# RESTAURANT DEPOT PARKING EXPANSION REPLAT

Minor Plat request to subdivide the lot into one.  
 The applicant proposes to re-plat the existing  
 Restaurant Depot (at 3451 W. Princeton St.) to  
 include portions of lot 82 and 83 as part of an  
 expansion to the existing parking lot.

**Updated:** June 30, 2014

# PROPOSED PLAT

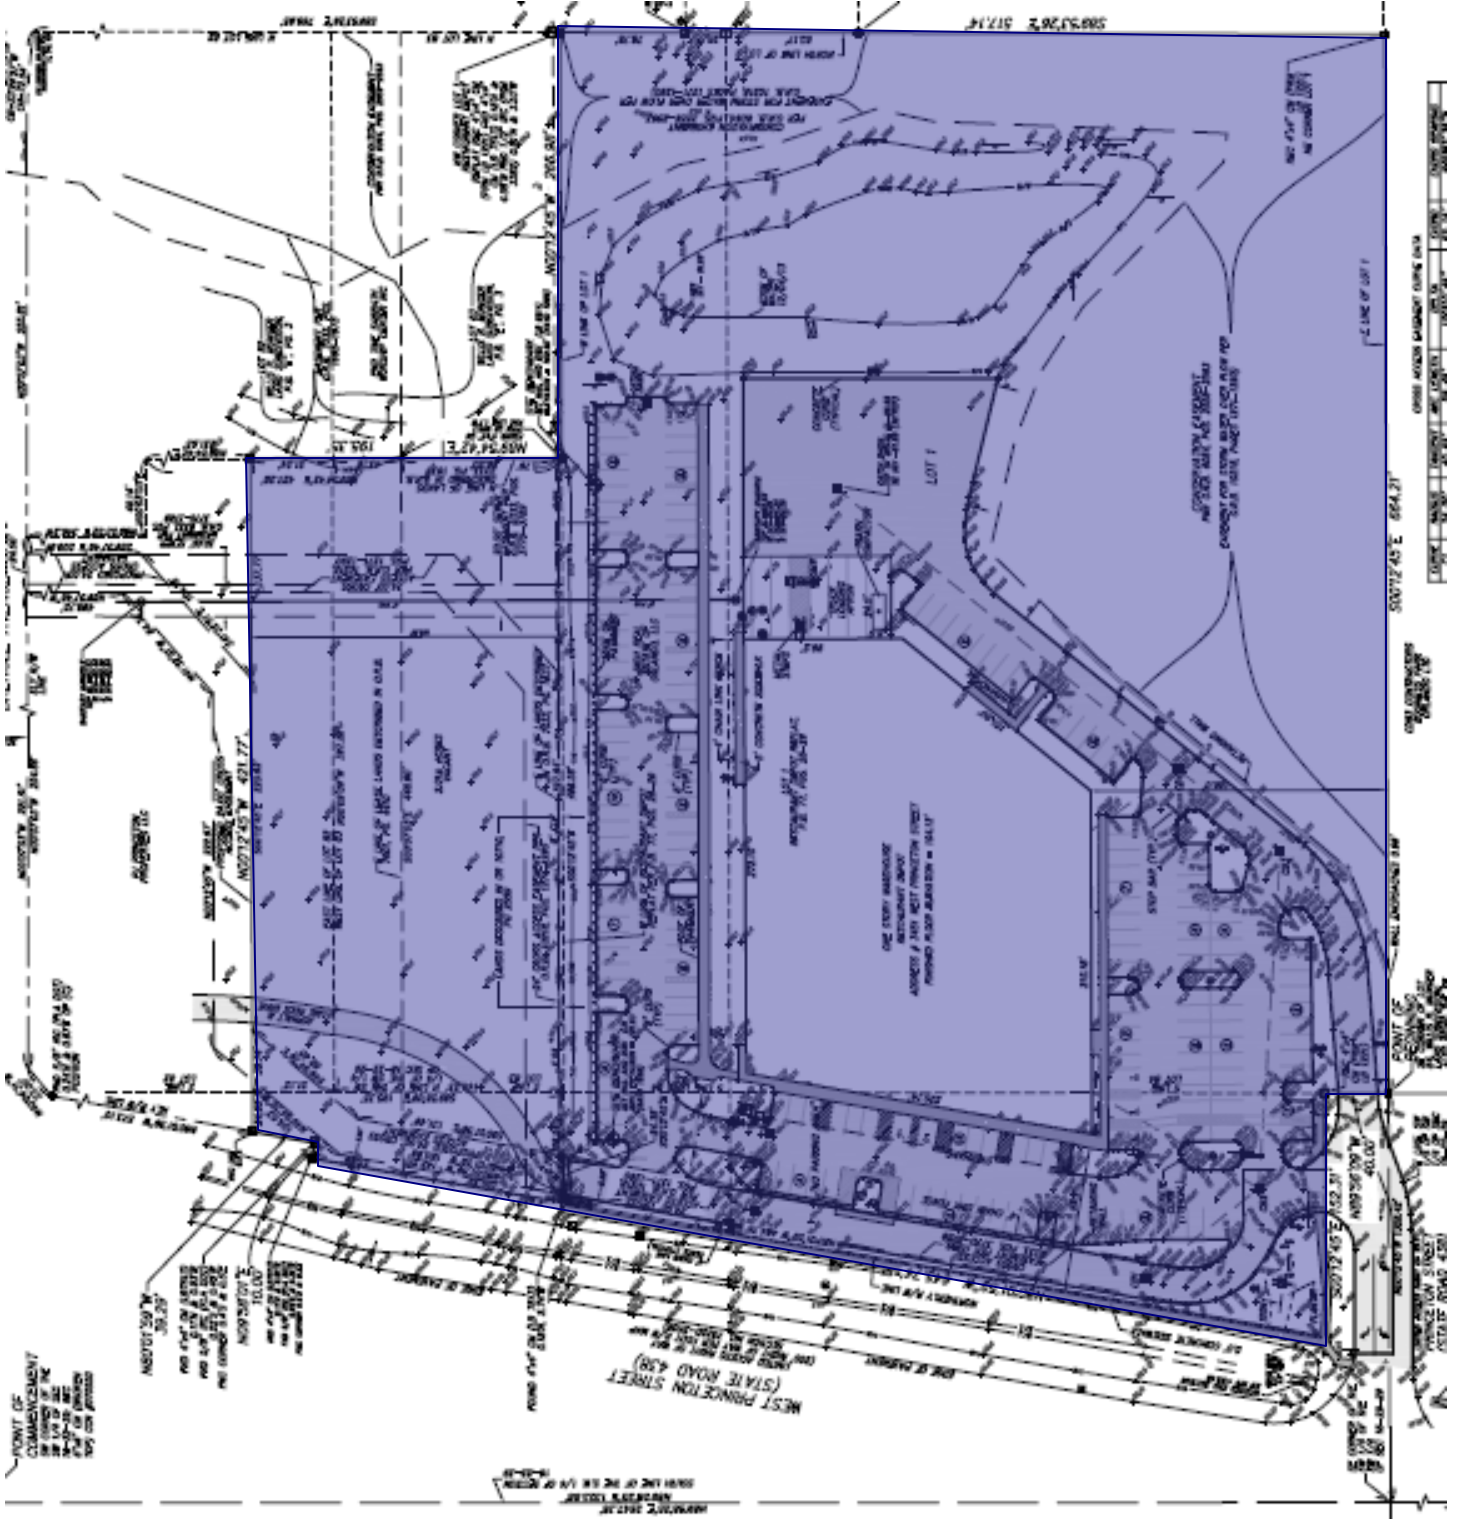
1. Easement Dedications. The Sidewalk & Utility easement on the western property line of this parcel adjacent to the Orange Av right-of-way shall be shown on this plat or accurately described in the attached notes. The cross access easement between this property and the parcel immediately northwest and adjacent shall be shown on this plot or accurately describe in the attached notes.
2. As per Section 61.225 of the Land Development Code, a 5 foot wide concrete sidewalk is required along all dedicated rights-of-way. Any existing sidewalk damaged or broken is to be repaired.
3. All utility and cross access easements must be shown on the face of the plat and in the boundary and topographic survey. The utility easement on the South side of the property is not shown on the boundary and topographic survey.

1. The utility easement recorded in 9623/4313 is shown on the certificate of title but not on the plat.
2. If there is to be a public dedication it must be specifically noted in the dedication block. If there is to be no public dedication it must be so noted in the dedication block as "nothing" or "N/A"

1. Remove the "PRINCETON STREET (STATE ROAD 438)" label on the East side of the plat. The main label "WEST PRINCETON STREET (STATE ROAD 438)" is sufficient.
2. Change "WEST PRINCETON STREET" to "W PRINCETON STREET" (No period after W) to indicate a directional indicator instead of West as part of the actual street name.
2. All blank spaces must be filled in prior to the recording of the plat.

1. Survey, Plat, & Title Opinion: All blanks must be filled in.
2. Various symbols and abbreviations are missing from the legend. FAC 5J-17.051(3)(b)(11)(b)

3. The symbology size varies and is inconsistent for same symbols.
4. Fencing is not show on the north end of the property, nor is any tie or dimension given. FAC 5J-17.052(2)(c)

5. No trees are shown as part of the topographic survey; they will need to be included.
6. Label the plat information for the property lying east of the subject property. FAC 5J-17.052(2)(a)(7)(a)

7. The survey needs to reflect the current title Commitment.
8. The legal description and plat certification report (Title Opinion) make reference to Willis R. Munger Land Subdivision, Plat Book E, Pages 3 and 3a. There is no page 3a.

9. Plat: Sheet 1: The legal description makes reference to The legal description and plat certification report (Title Opinion) make reference to Willis R. Munger Land Subdivision, Plat Book E, Pages 3 and 3a. There is no page 3a.

10. Plat: Sheet 1: Ensure there is consistency between sheet one and sheet two legends.
11. Plat: Sheet 2: The dedication needs to clarify that nothing is being dedicated for the use of the public and the public dedication is not applicable.

12. Plat: Sheet 2: The boundary and topographic survey shows a retention pond on the North side of the property just outside of the conservation tracts. The pond is not encumbered by any easement and not shown on the replat or this second replat.

13. Plat: Sheet 2: Add FDOT to the legend.
14. Plat: Sheet 2: Label each easement as private or public.
